SERVICE LETTER 269

WATER RUDDER REMOVAL ON 10000 LEFT HAND FLOAT

Aircraft Makes/Model(s):	Float Model(s):	Compliance: Optional	By: MAS
Air Tractor AT-802A & AT-802	10000A	Part Number: 1012726 Date: 1/20/2025	Approved: DRH Revision: A

FIGURE 1: 2-WATER RUDDER CABLE ROUTING

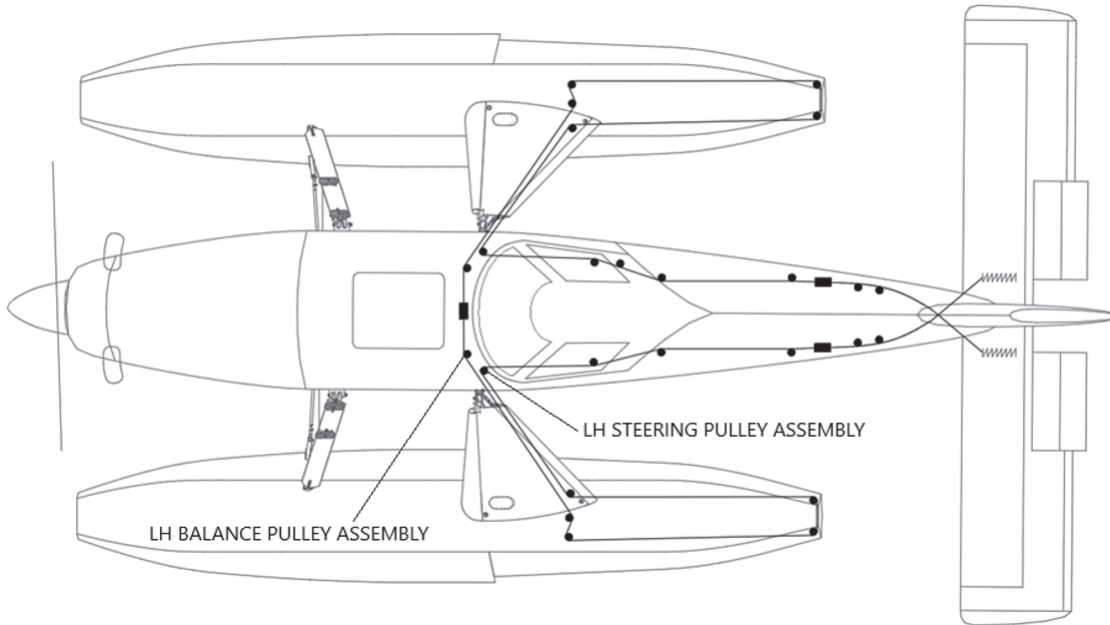
The existing water rudder steering cable routing with both water rudders installed is shown in Figure 1. Each steering cable runs from the aircraft rudder horn, through the fuselage, down each respective pylon, and through each float to the water rudder. A balance cable then travels between the two float water rudders to complete the steering cable system. Note that there is a turnbarrel in each wire run for adjustment.

FIGURE 2: SINGLE WATER RUDDER CABLE ROUTING

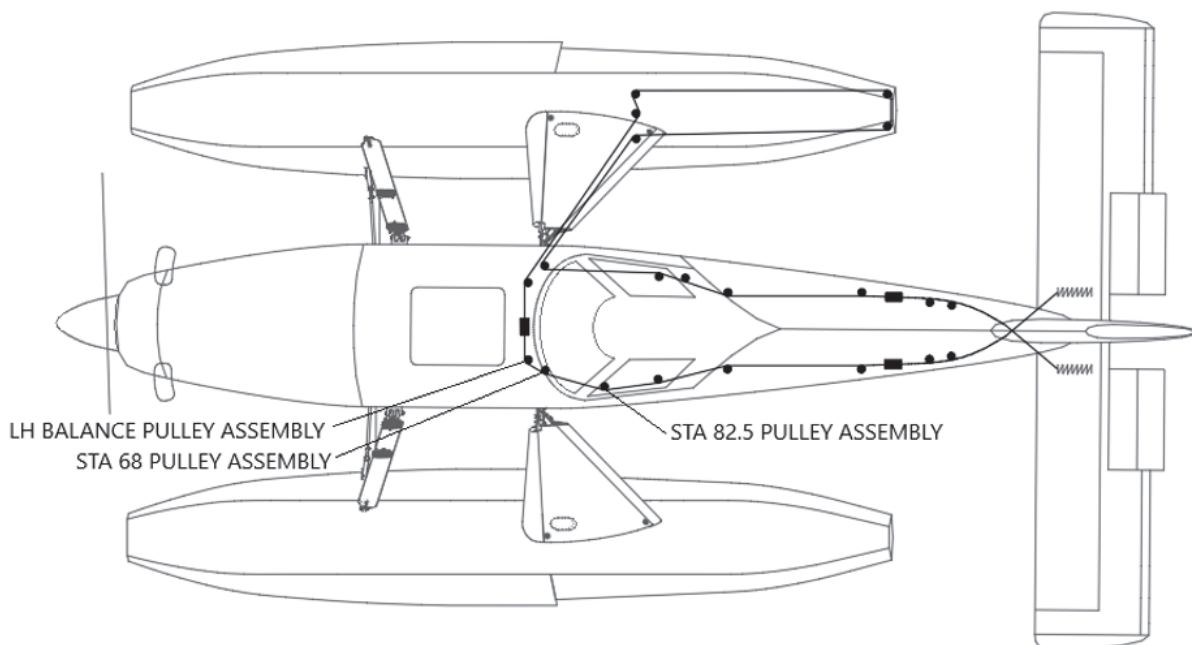
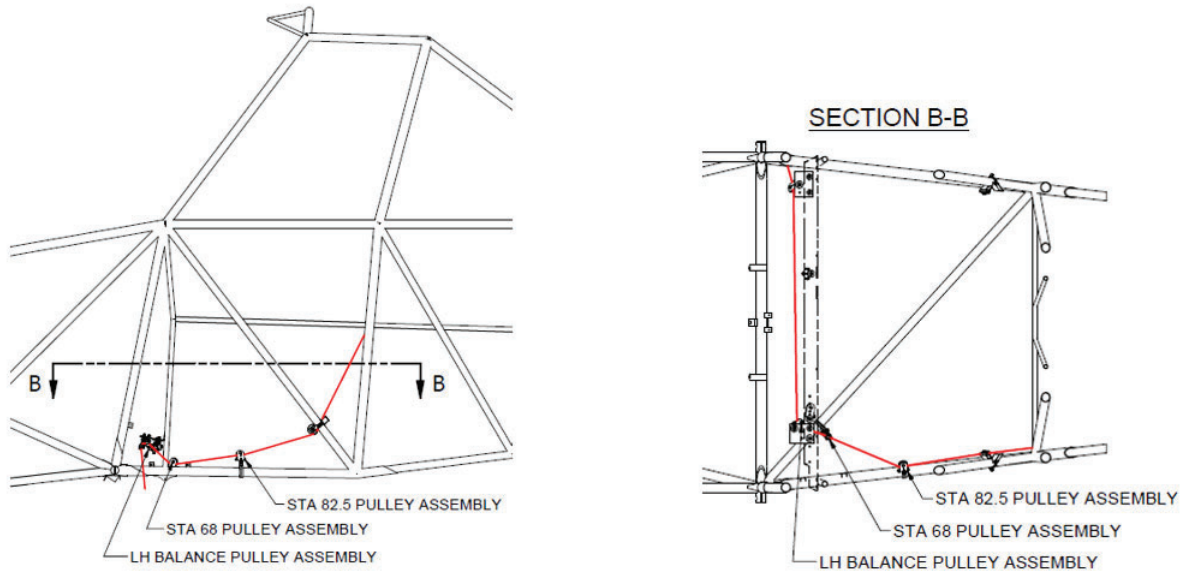
The removal of the water rudder from the LH float requires a change to the water rudder cable routing making 2 steering cables that run from the aircraft rudder to the RH water rudder. The LH steering pulley is removed, pulley assemblies at STA 82.5 and 68 are added, and the LH steering cable and balance cable are combined to create the new steering cable. See Figure 2 and Figure 3 for overview reference.

FIGURE 4: LH WATER RUDDER PARTS

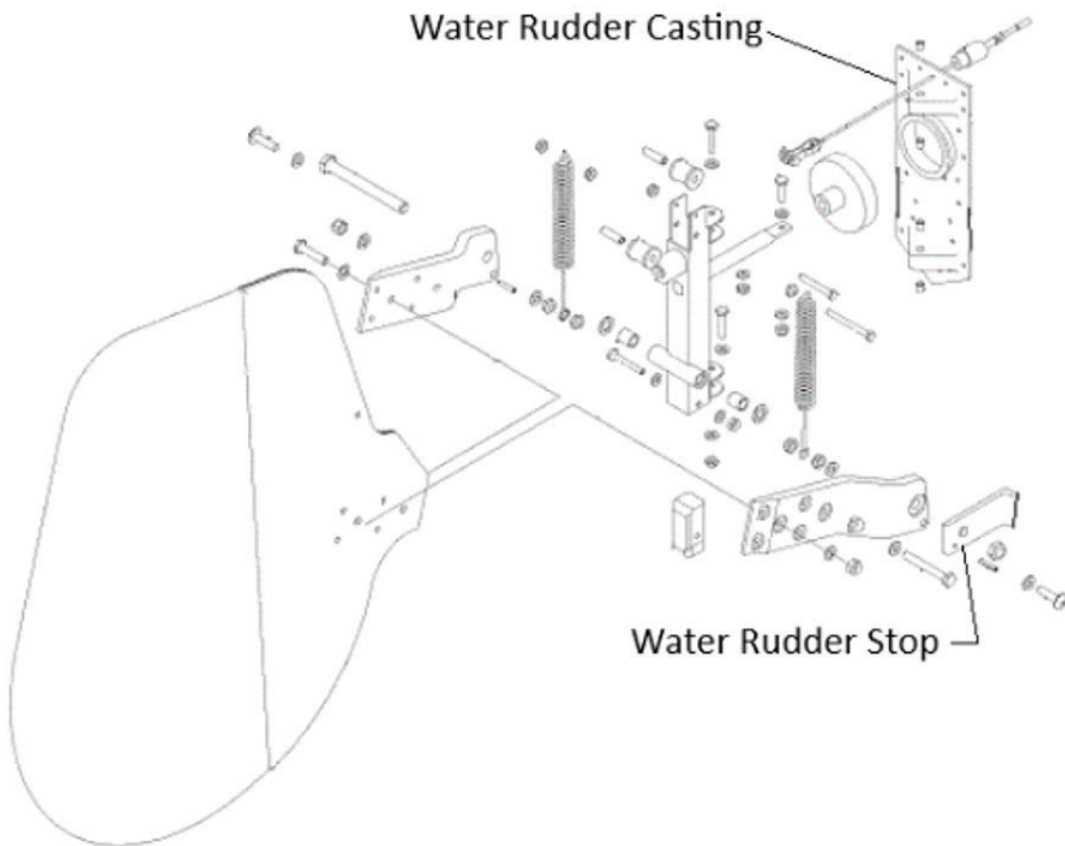
1. Put the water rudders in the down position. If the water rudder system has an electric retract motor, pull the circuit breaker "W.R. RETRACT."
2. Disconnect the retract cable, steering cable, and balance cable from the LH water rudder attachment location at the aft end of the LH float.
3. Cable ends can be cut and removed through the LH float and the LH pylon. The retract cable can be completely disconnected and removed. Leave the steering and balance cables at length until it is determined how the cables will be run and terminated in Step 16.
4. With cables out of the way, remove all LH water rudder parts attached to water rudder casting 3A01437-001. Keep water rudder stop 10A08426-012 to be added to the RH water rudder.

5. Drill out the rivets to remove water rudder casting 3A01437-001
6. From the inside of the float, drill out the rivets and remove pulley bracket guide mount 10A08033-004.

FIGURE 5: BULKHEAD #22 PARTS

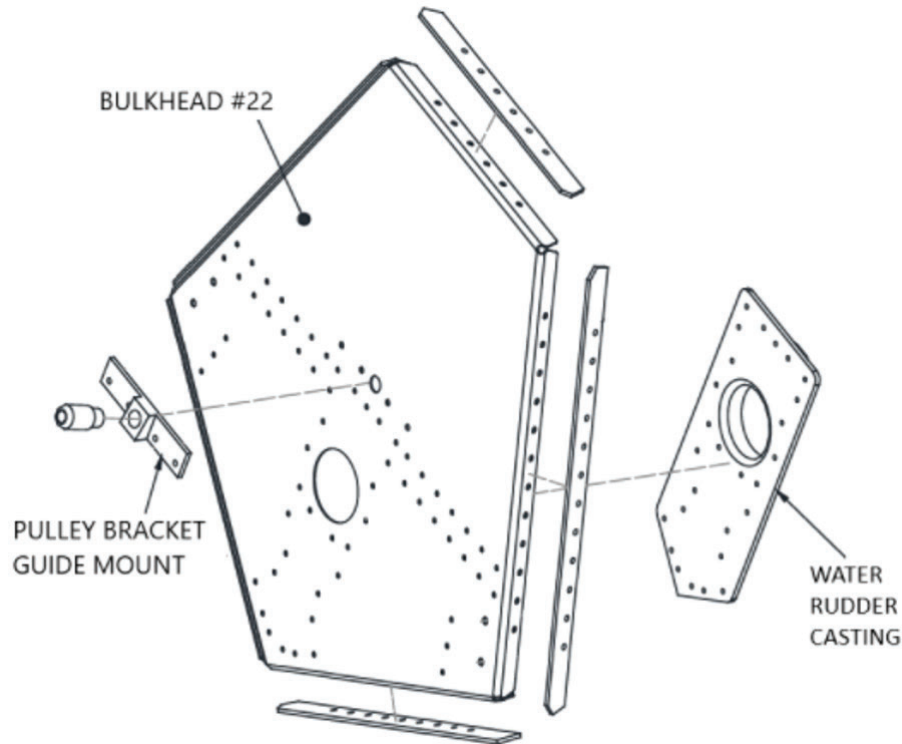
7. Use water rudder bulkhead cover 1012705 on the aft side of bulkhead #22. Use PR-1422 sealant between the cover and the bulkhead before riveting. Fill existing holes in bulkhead #22 with rivets.
8. For the remaining sections of the LH float and pylon, it is left to the discretion of the customer or installer regarding how to fill the holes left by removing the cables or whether any other pulleys and brackets are removed. Sections must be repaired in accordance with AC43.13-1B or 1008274.
 - a. Additional water rudder cable cover parts 1012706 are included in this service letter kit to replace the pulley bracket guides (10A08251-004/10A08251-005) in bulkhead #21.

FIGURE 7: AUXILIARY PULLEY ASSEMBLY

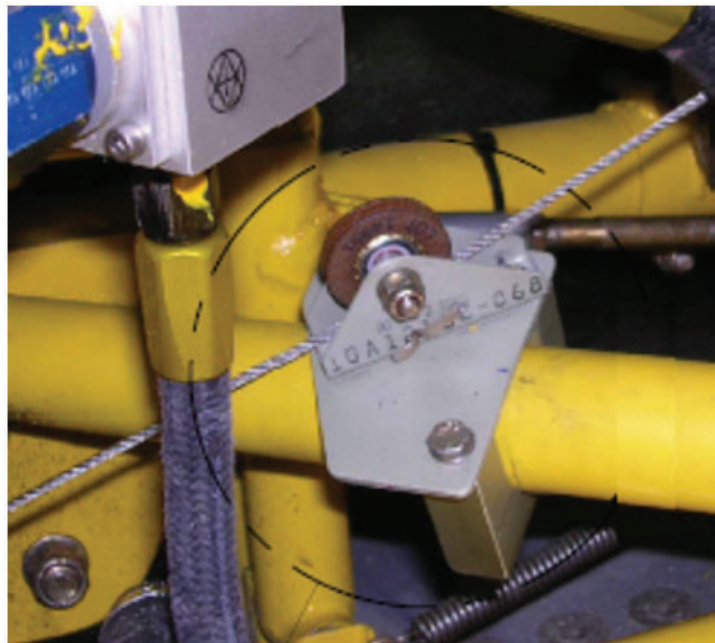
10. Remove the LH side auxiliary retract pulley if installed.

FIGURE 8: PULLEY BRACE AT STA 67.88

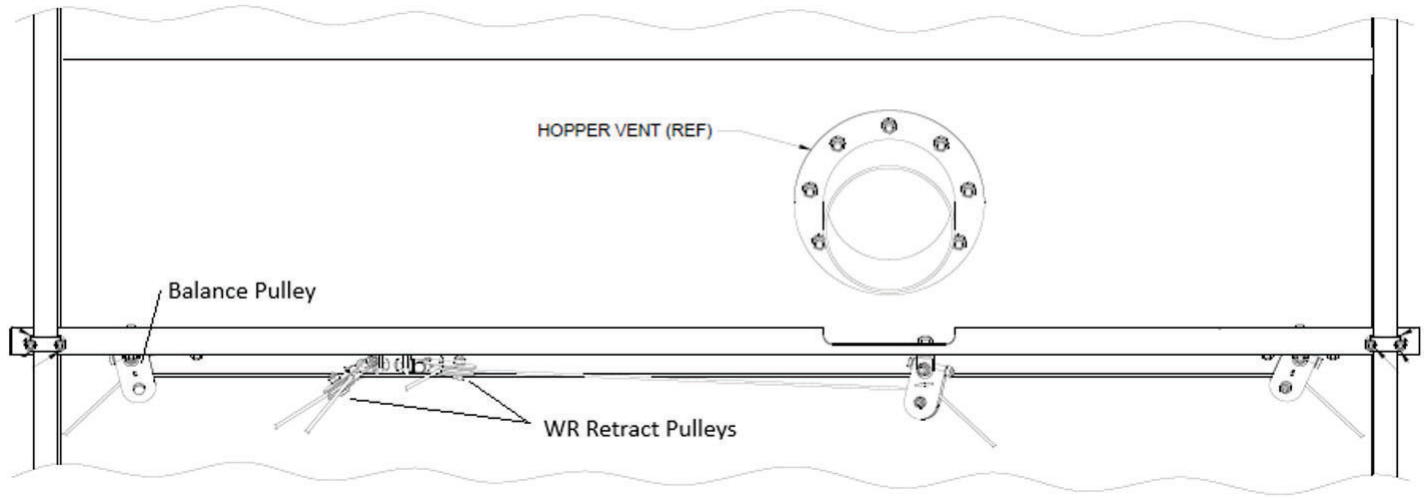
11. The next step is to reconfigure the pulleys on the brace mounted to vertical fuselage tubes at STA. 67.88. Figure 8 view is looking forward at the aft side of the hopper.

- a. Remove the RH WR Retract Pulley. The LH WR Retract Pulley becomes the single water rudder retract pulley that will direct the single cable to the RH float.
- b. The Balance Pulley and plate assembly needs to be moved and reconfigured for the new cable routing. Remove the plate from the long angle bracket, remove pulley assembly from the plate, rotate the plate 90 degrees counterclockwise, and move it as far inboard as you can without interfering with the WR Retract Pulley. Reattach the plate to the long angle bracket and reattach the pulley assembly to the forward-most hole on the plate. Holes may have to be drilled to size to fit hardware. Make sure that eye bolts are not over-tightened such that they cannot turn to adjust pulley position.

FIGURE 10: PULLEY ASSEMBLY AT STA 82.5

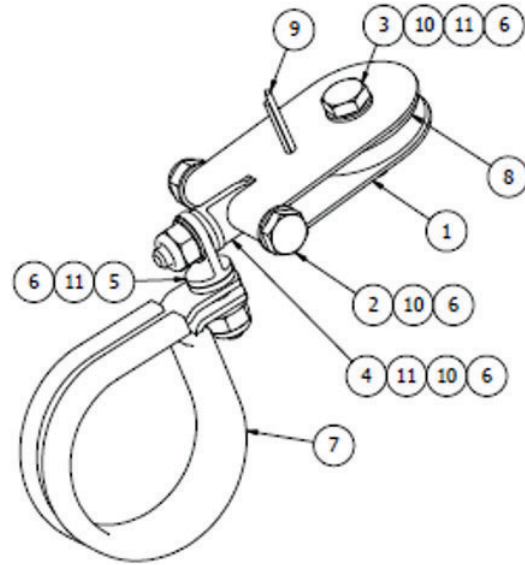
12. With parts included in this service letter kit, create the STA 82.5 Pulley Assembly, with the MS21919WDG26 clamp, and attach it to the bottom left fuselage tube approximately at STA 82.5. Pulley assembly position can be adjusted rotationally and longitudinally as needed for cable routing and clearance with other components. While the eye bolt going through the clamp must be tight, the eye bolt going to the pulley must be loose enough that the bolt can turn for proper pulley degrees of motion.

FIGURE 11: PULLEY ASSEMBLY AT STA 68

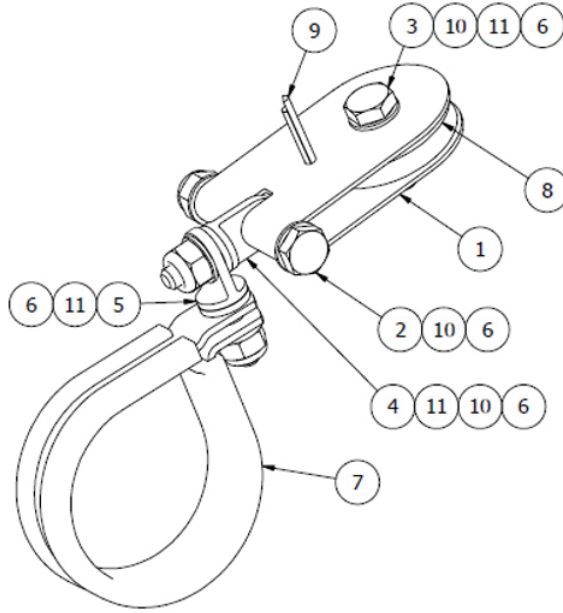
13. With parts included in this service letter kit, create the STA 68 pulley assembly, with the MS21919WDG22 clamp, and attach it to the bottom diagonal fuselage tube approximately at STA 68.0. Pulley assembly position can be adjusted rotationally and diagonally as needed for cable routing and clearance with other components. While the eye bolt going through the clamp must be tight, the eye bolt going to the pulley must be loose enough that the bolt can turn for proper pulley degrees of motion.

FIGURE 12: MANUAL RETRACT CABLE PULLEY ASSEMBLY

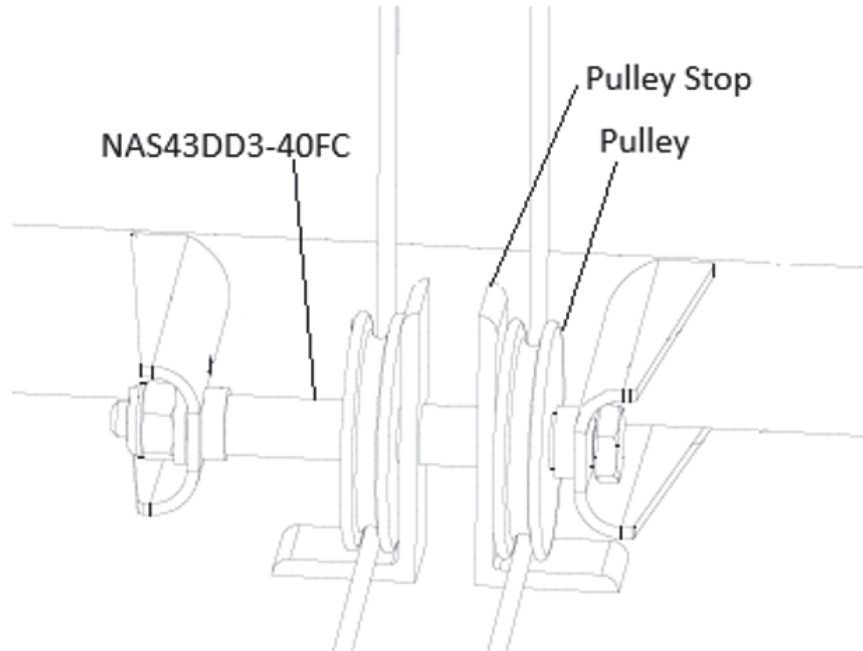
14. If the aircraft has a manual water rudder retract system, there is a retract pulley assembly at STA 102.56. Remove the outboard pulley/pulley stop, move the small spacer and the other pulley stop/pulley outboard, and replace spacer NAS43DD3-40FC with spacer NAS43DD3-64FC.

FIGURE 13: 2-WATER RUDDER CABLE SCHEMATIC

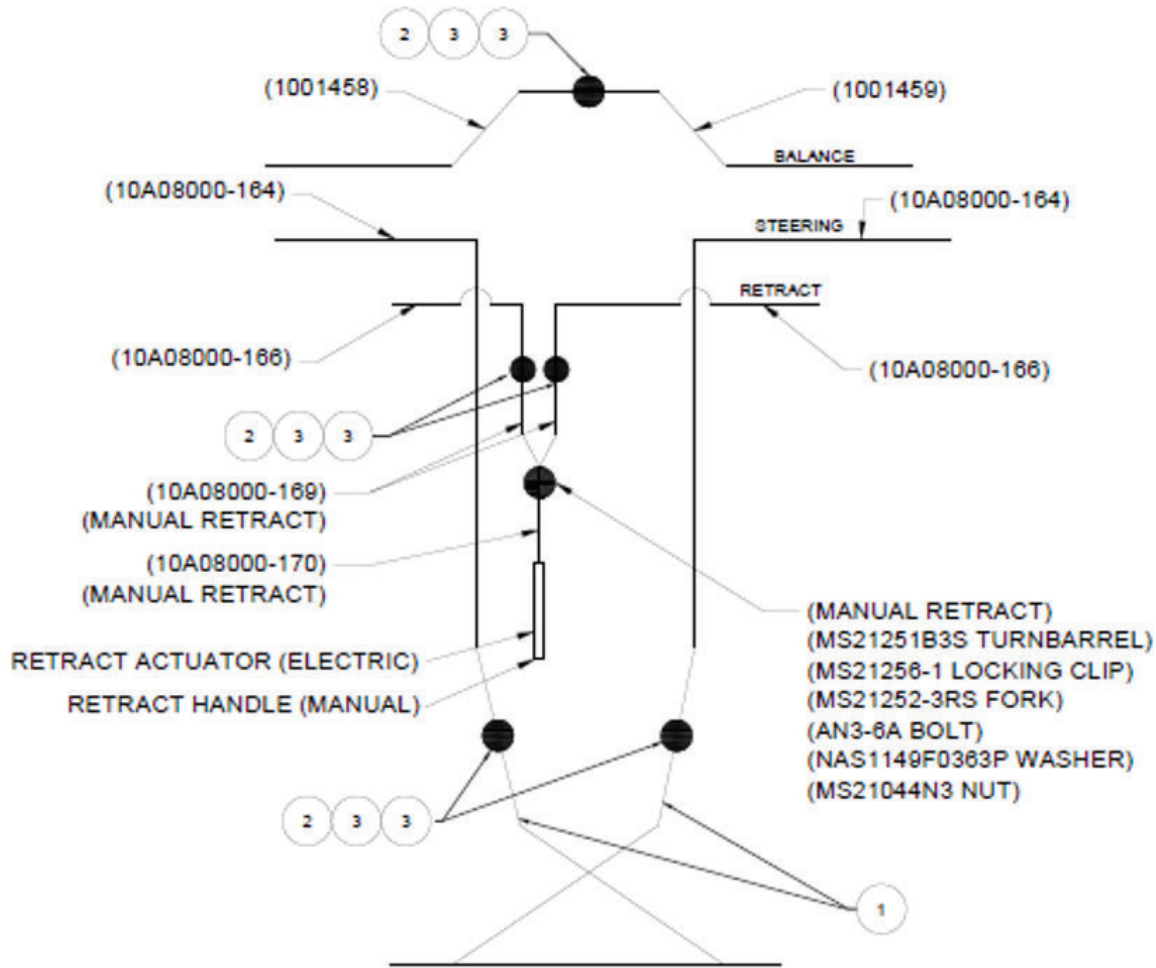
- a. Route and adjust cable assemblies with flaps in up position.
- b. Set steering cable tension to 10 lbs +5/-0.
- c. Figure 13 is a cable routing schematic for the existing 2-water rudder installation where Item 2 is MS21251B3S (turnbarrel), and Item 3 is MS21256-1 (turnbarrel locking clip).

FIGURE 14: SINGLE WATER RUDDER CABLE SCHEMATIC

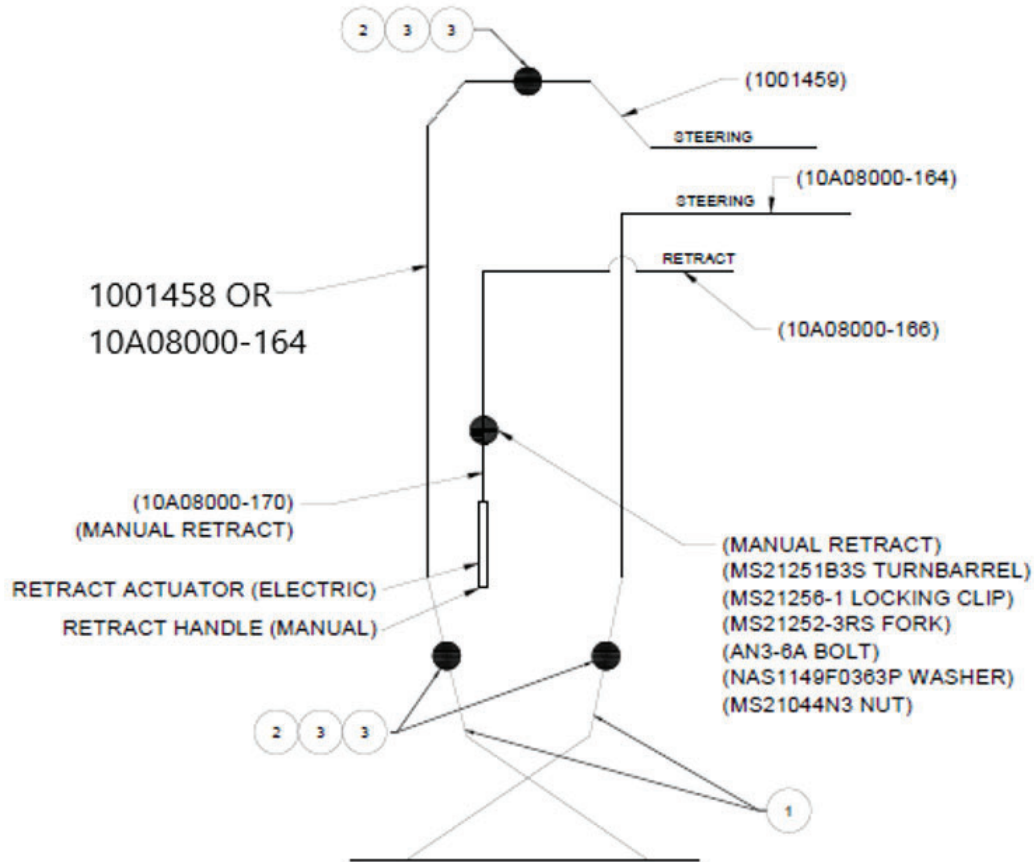
- d. LH retract cable 10A08000-166 is removed in Step 3.
- e. Steering cable 10A08000-164 and balance cable 1001459 must be joined such that the cable runs from the rudder horn, through the fuselage existing pulleys, through the newly assembled pulleys (Steps 11b, 12, and 13), and down the pylon to the RH water rudder.

- i. Installer can remove steering cable 10A08000-164, route balance cable 1001458 to the turnbarrel in the aft fuselage, cut cable to the correct length, and add a new terminal stud to be reassembled with the turnbarrel.

- ii. Installer can remove balance cable 1001458, route steering cable 10A08000-164 to the turnbarrel at STA 67.88, cut cable to the correct length, and add a new terminal stud to be reassembled with the turnbarrel.

- iii. Note that both of these options will result in the steering cable run having 2 separate turnbarrel locations. This cable configuration can be modified at the installer's discretion provided at least one turnbarrel assembly is included in the cable run for adjustment purposes.

FIGURE 15: WATER RUDDER STOP

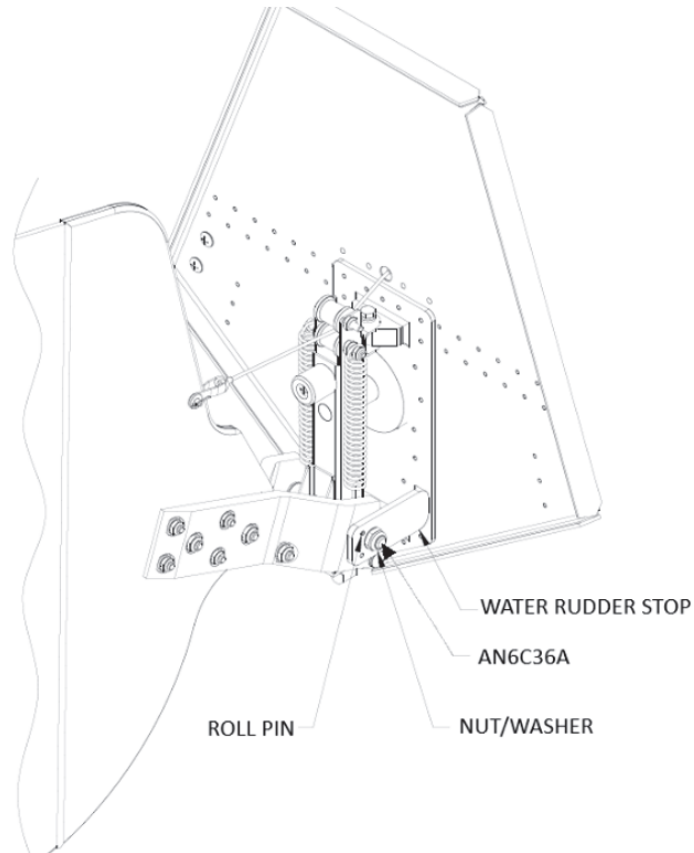
17. The water rudder stop from the LH water rudder needs to be attached to the opposite side of the RH water rudder such that there is a stop on both sides of the RH water rudder. Position water rudder stop square to bulkhead with water rudder in the up position. Match drill 0.125 hole from water rudder stop through water rudder arm. New roll pin and longer bolt (AN6C36A) are included in this service kit.
